SUBJECT: LICENSING ACTION REVIEWS FOR SURRY POWER STATION,  
UNIT 2 - ASME XI INSPECTION RELIEF REQUEST (TAC 59754)

SUBJECT: Requests relief from certain ASME Boiler & Pressure Vessel Code, Section XI requirements, per 10CFR50.55(a), Bases for request discussed.

VIRGINIA ELECTRIC AND POWER COMPANY  
SURRY POWER STATION UNIT 2  
ASME XI - INSPECTION RELIEF REQUEST

# REGENERATIVE HEAT EXCHANGER

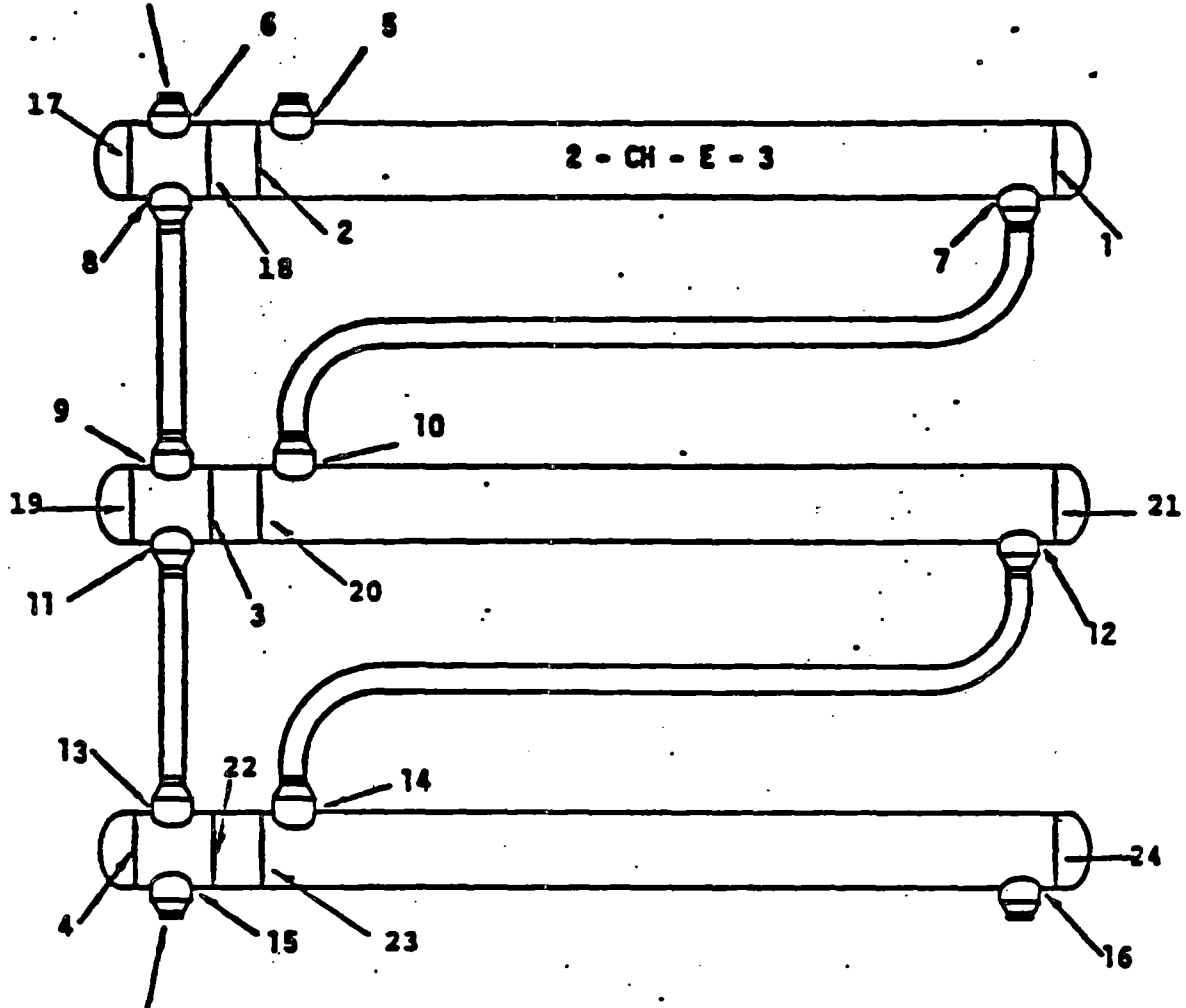
1. The regenerative heat exchanger (2-CH-E-3) is classified ASME Class 1 in the first interval inspection plan (ASME XI 74 edition, Summer 75 addenda). The following items were scheduled per table IWB-2600 to be completed during the refueling outage on the regenerative heat exchanger (Regen Hx):

Table IWB-2600 Item No.	Table IWB-2500 Examination Category	Parts to be examined (attachment 1)	Method
B3.1	B-B	Head to shell weld(17)	Volumetric
B3.1	B-B	Shell to tube sheet weld(18)	Volumetric
B3.2	B-D	Nozzle to vessel welds(5,6,7,8,9,10,11,12,14, and 16)	*substituted surface

Preinspection meetings with the Health Physics Department determined that unreasonable doses would result from completion of these examinations. The close quarters surrounding these components limit shielding and allow effective use of only one individual to remove insulation (Regen Hx only), perform necessary surface preparation, perform the inspection, and reinsulate (Regen Hx only). In addition surface preparation time can be extended significantly as a result of the limited preservice examination requirements associated with the earlier codes. In many cases this has left these type of welds in poor surface condition for examination.

# SEAL WATER RETURN FILTER

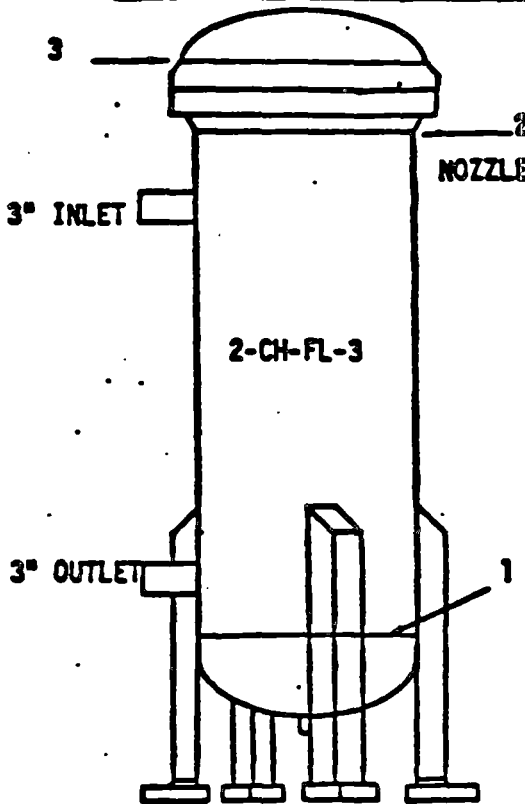
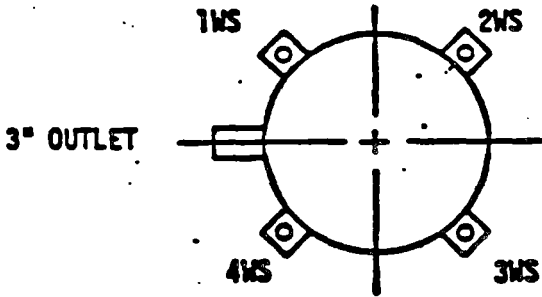
The seal water return filter (2-CH-FL-3) is classified ASME Class 2 in the first interval inspection plan (ASME XI 74 edition, Summer 75 addenda). The following items were scheduled per table IWC-2600 to be completed during the refueling outage on the seal water return filter:

Table IWC-2600 Item No.	Table IWC-2500 Examination Category	Parts to be examined (attachment 2)	Method
C1.1	C-A	1" head to shell weld(1)	*substituted surface and visual
C1.1	C-A	1" shell to flange weld(2)	*substituted surface and visual
C1.1	C-A	1" top head weld(3)	*substituted surface and visual
C1.3	C-C	Welded support (IWS)	surface

**VALVE OPERATING NUMBERS  
RESIDUAL HEAT REMOVAL**

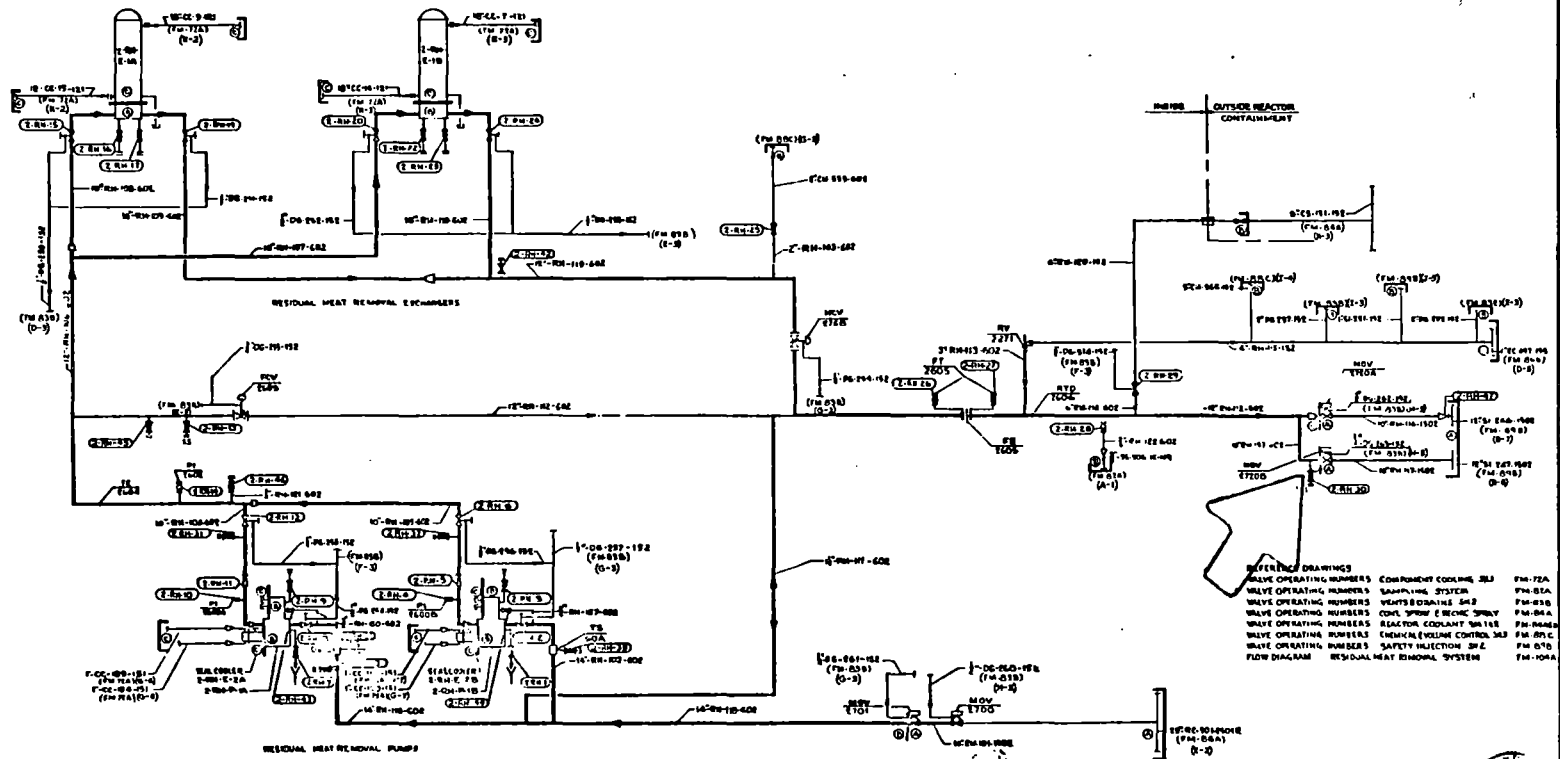
2. The residual heat removal return isolation valve (MOV-RH-2720B) is classified ASME Class 1 (attachment 3). A Table IWB-2600, (ASME XI 74 edition, Summer 75 addenda) item B6.7, category B-M-2, valve internal visual inspection was required this refueling outage. A substituted thickness measurement examination from the exterior wall was attempted. This alternative was approved by relief request on January 24, 1984 (letter Mr. Varga to Mr. Stewart), relief request SR-1.

Therefore, it is requested that acceptance of the system hydrostatic pressure test be allowed as the alternative examination requirement. These tests (Class 1 to Class 2 boundary valve) were completed with the associated VT-2 examinations on July 1, 1983 and April 22, 1985 at test pressures of 600 psig and 750 psig, respectively.

**VALVE OPERATING NUMBERS  
 SAFETY INJECTION SHEET 2**

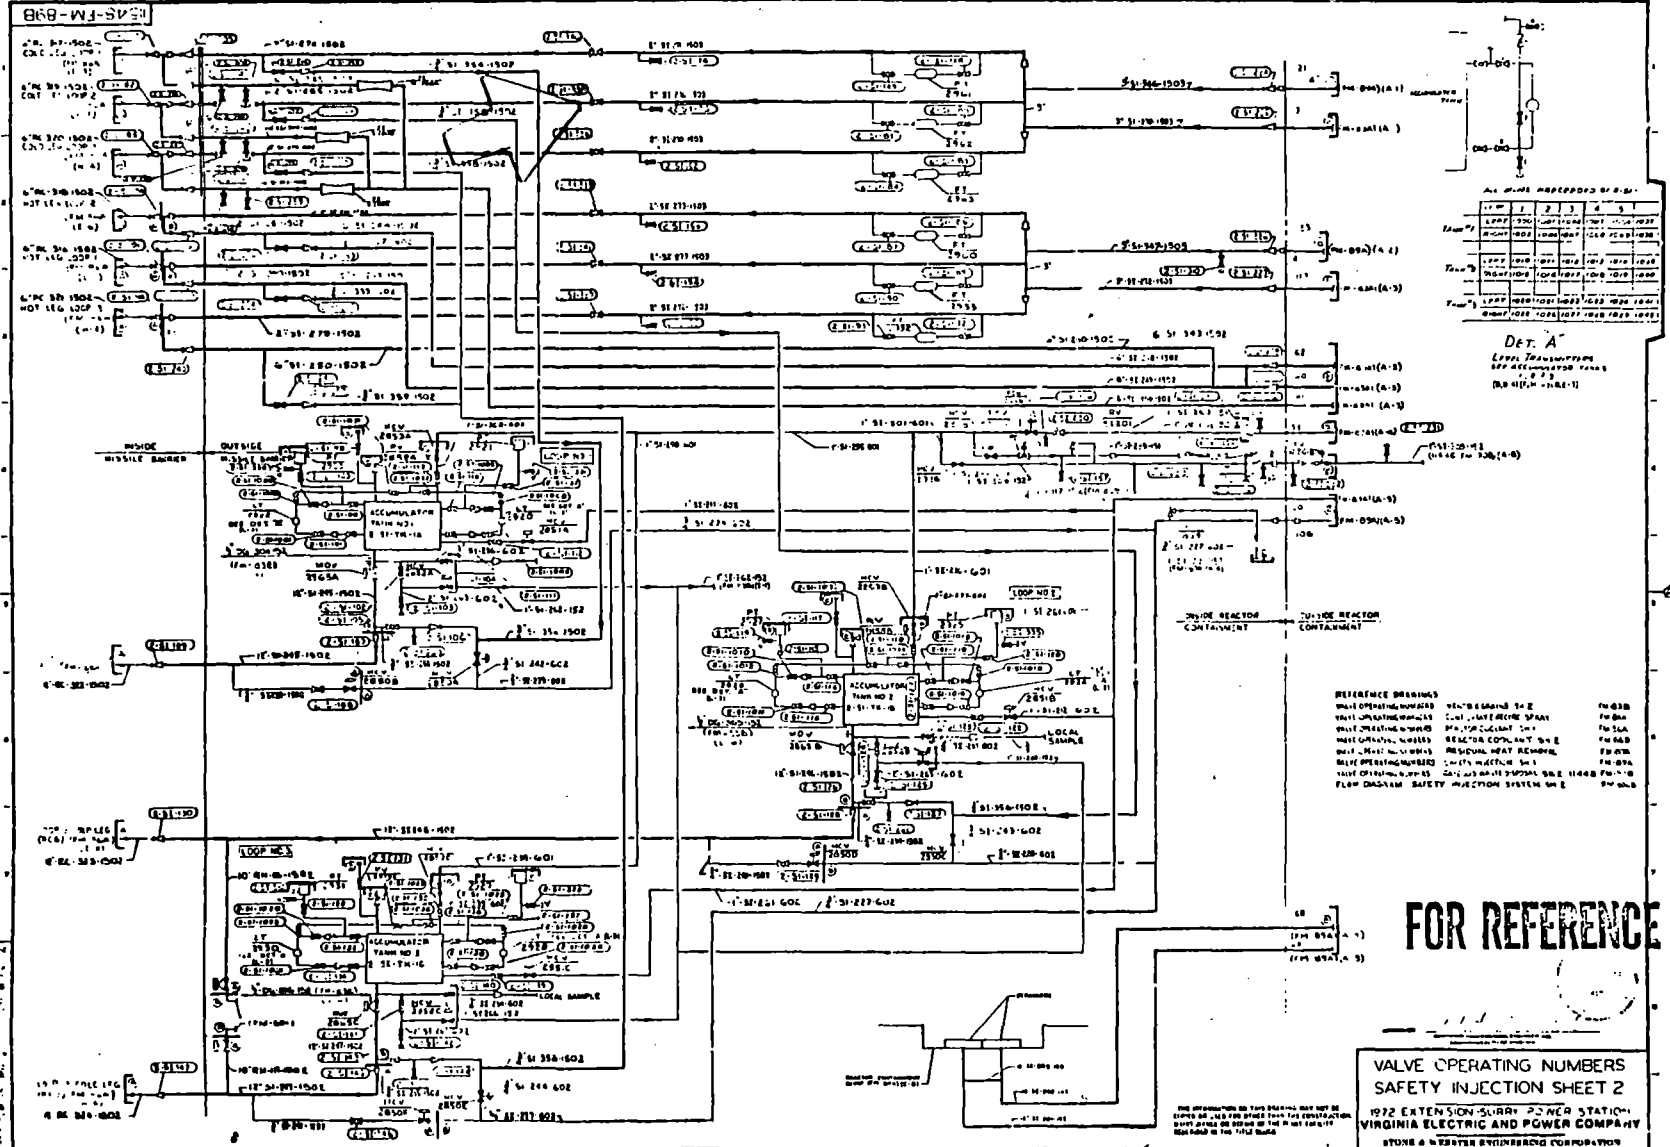
Specific use of this relief was already applied during the outage in the replacement of 2-SI-338, a 2 inch ASME Class 2 manual valve (attachment 5), used in setting flow for the high head safety injection system. Procurement of a valve meeting the original construction code and nuclear code cases could not be made, however the original manufacturer stocked a valve, which met ASME Section III NC requirements, except for stamping and met the requirements of ASME Section XI, IWA 7210 (c) as discussed.
